STATE OF WASHINGTON  
**DEPARTMENT OF ECOLOGY**

**Re: Opinion on Proposed Preliminary Investigation Work Plan for the following Site:**

- **Site Name:** Columbus Square
- **Site Address:** 614 S. Columbus Avenue, Goldendale
- **Facility/Site ID No.:** 81593498
- **Cleanup Site ID No.:** 6704
- **VCP Project No.:** CE0536
- **Work Plan Title:** Preliminary Remedial Investigation Report and Work Plan

**Site Diagram**

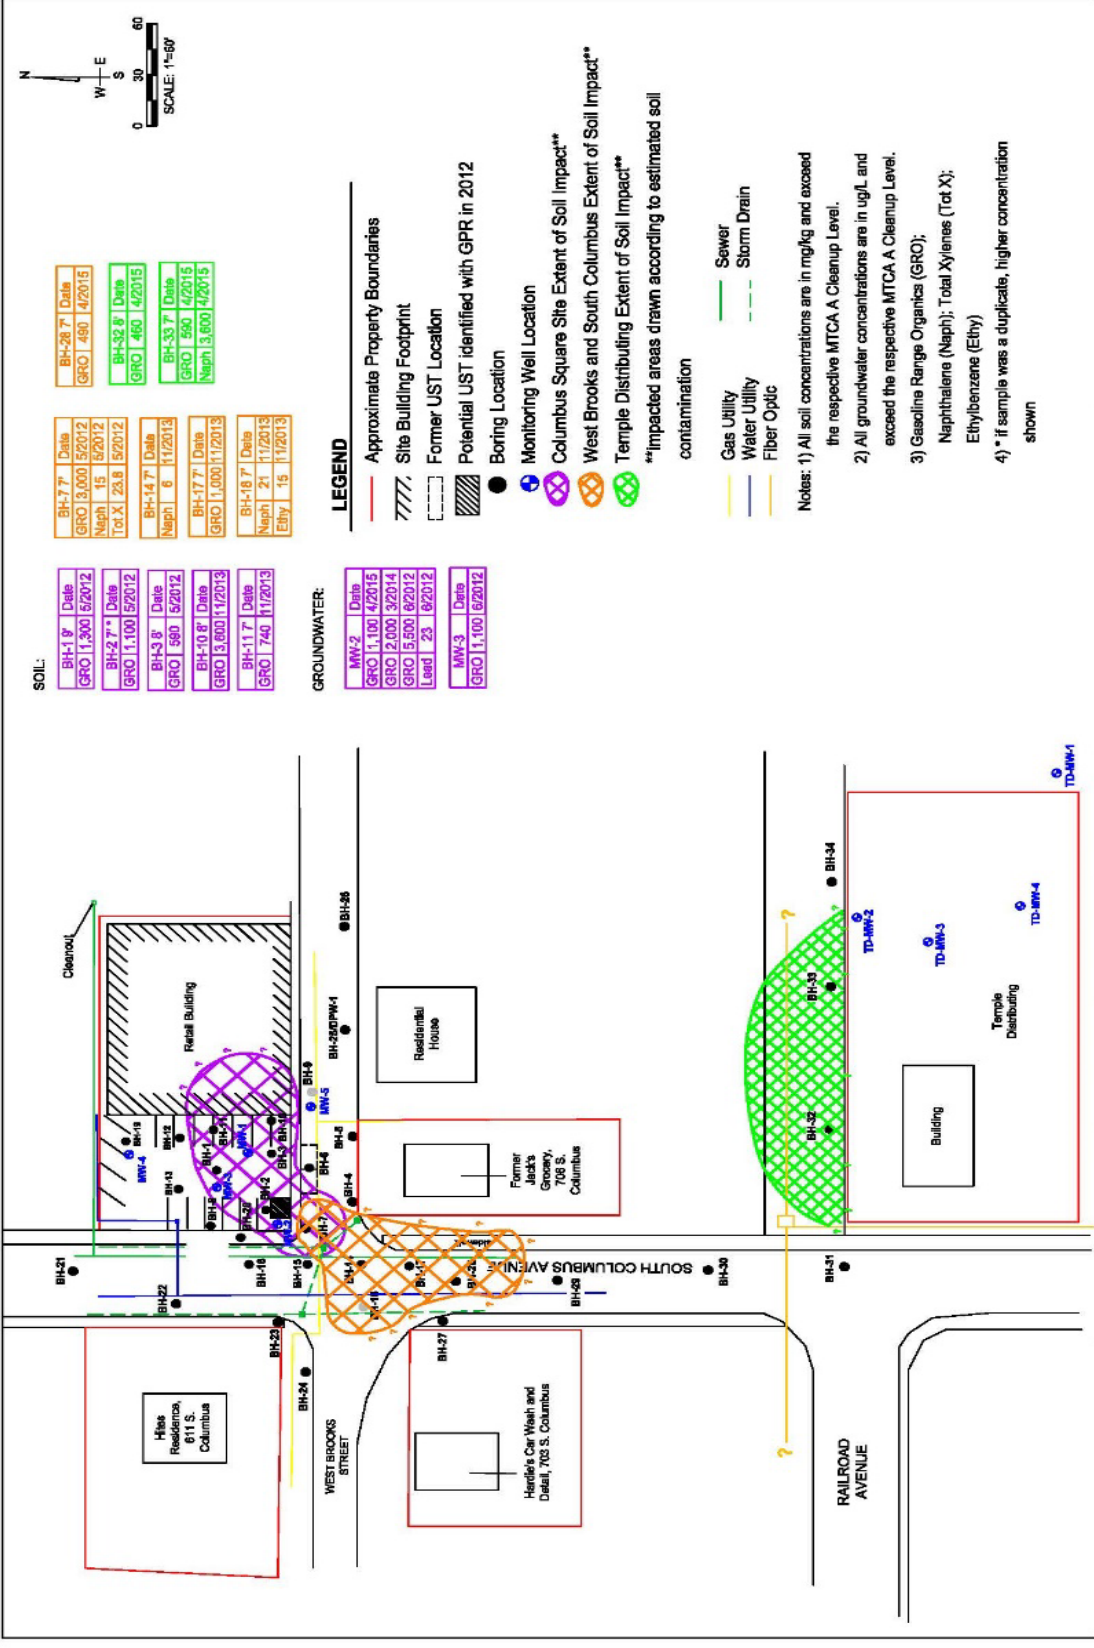
1. Approval of proposed work plan for refining the conceptual site model is based on the following:
  - 1) Provides for the assessment of the vapor intrusion exposure pathway for the contaminants of concern at the Site. Three sub-slab soil Vapor Pins<sup>®</sup> will be installed and the soil gas will be sampled.

- 2) Proposes two borings and associated sampling that are positioned to interpolate the east boundary of the contamination at the downgradient portion of the property.

- 3) Proposes a temporary monitoring well along with associated sampling at a location south-southwest of MW-2 and BH-7. This boring is positioned to assess the upgradient portion of the groundwater plume at the Columbus Square Site.

- 4) Provides for additional groundwater monitoring to assess the contaminant concentration trend at the property.
  - 5) Proposes a GPR survey and the use of a vacuum truck to confirm the presence or absence of an UST that may have been abandoned at the southwest corner of the property near boring BH-2. A previous GPR survey showed the presence of a magnetic anomaly indicating the likely presence of a tank. A soil boring will be completed if the UST is not present.

- 6) Proposes two borings and associated sampling to collect additional soil data in the vicinity of historical impacts near BH-1 and BH-10.
2. Two other petroleum hydrocarbon sites exist in close proximity to the Columbus Square Site. Either or both sites may be contributing contaminant source mass in proximity to the Columbus Square property as suggested in the attached site diagram. If so, then any commingling of groundwater contamination may likely contribute to fluctuation in contaminant concentrations above the applicable MTCA Method A cleanup levels at the Site.

Note that this work plan does not assess whether contaminated groundwater has migrated within the utility trench backfill. There is the possibility that the utility trench backfill may provide a more permeable pathway than the surrounding subsurface soil matrix, which is fine-grained.
